1675 WEST 8TH AVENUE (COMPLETE APPLICATION)
DE409080 - ZONE C-3A

DEVELOPMENT PERMIT STAFF COMMITTEE MEMBERS

- **Proposal:** To construct a 77 unit residential development with an 11 storey residential tower, townhouses at grade and 2.5 levels of underground parking and incorporating a transfer of 766.4 m² (8,251 sq. ft.) of heritage density.

DEVELOPMENT PERMIT STAFF COMMITTEE RECOMMENDATION: APPROVE

Figure 17. Height and Length Limits

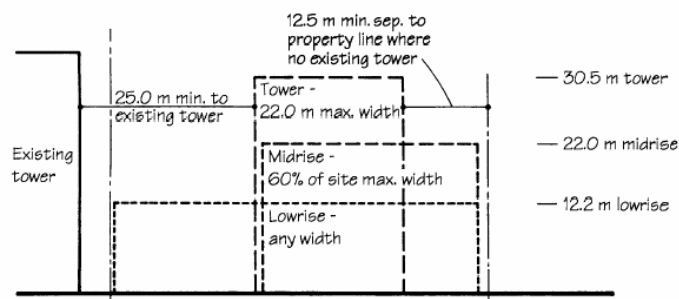
The mid-rise massing width suggested in the guidelines is a maximum of 60% of the width of the site, where a slightly thinner massing of 55% is proposed which provides benefits for views and shadowing.

The tower floor plate dimensions are 3 ft wider than the guideline suggested (75.3 ft vs. 72 ft) but is 5 ft shorter in depth (83 ft vs. 88 ft) than the guidelines suggest. Staff have reviewed the impacts of the extra width and note that this does not have direct view or shadow impacts. Considering this in conjunction with the narrower massing and the smaller floor plate, staff support this variation of the tower floor plate dimensions.

Figure 2. Massing and Shadow Analysis of Proposed Development

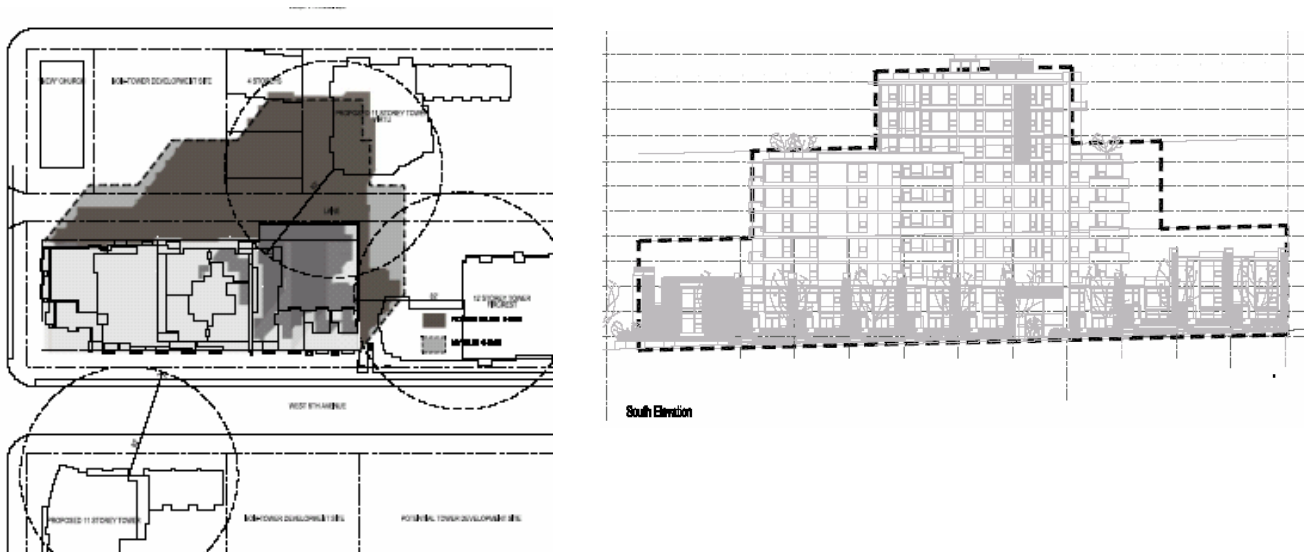
Height, Views and Shadowing: Analysis shows that the massing provides benefits at the mid-rise width at 55% being less than the guideline suggested at 60% but exceeds the guideline in tower and shoulder height at the rear of the site. The height of the building is also at or below the guideline heights including handrails, at the front of the site, on 8th Avenue but exceeds the height at the rear due to site slope. Staff note that ceiling heights for the residential are proposed at 9'-2" up to the 8th floor and 9'-8" on the 9th to 11th floors, where 8'-8" has traditionally been the floor to floor height for concrete towers. However, staff generally support the increased floor heights for liveability provided the impacts associated with these increases can be minimized.

Given that an existing 4 storey artist live/work development with a courtyard is across the lane to the north and that future development beside it will not likely achieve a tower due to the separation criteria according to the guidelines, staff suggest that there should be more shadow benefits provided to the existing and future residents directly to the north.

In condition 1.2, staff suggest that the proposal be further scaled back to meet shadow criteria suggested by the massing controls in the guidelines, at the mid-rise and tower levels. This can be relatively easily achieved by minimizing overhangs and setting back the extensive balconies on the north side on the 8th and 11th floors.

With respect to views, a number of southern neighbours would be affected by views through the site. Staff suggest improvements to the tower roof by aligning the roof access stairs and by setting back the decks and handrails on the mid-rise roof by approximately 6 ft under condition 1.1.

- 1.2 design development to reduce the shadow impacts of the mid-rise and tower massing;

Note to Applicant: This can be achieved by reducing the slab extensions and setting back the balconies on the north side of the mid-rise (8th floor) and tower (11th floor).
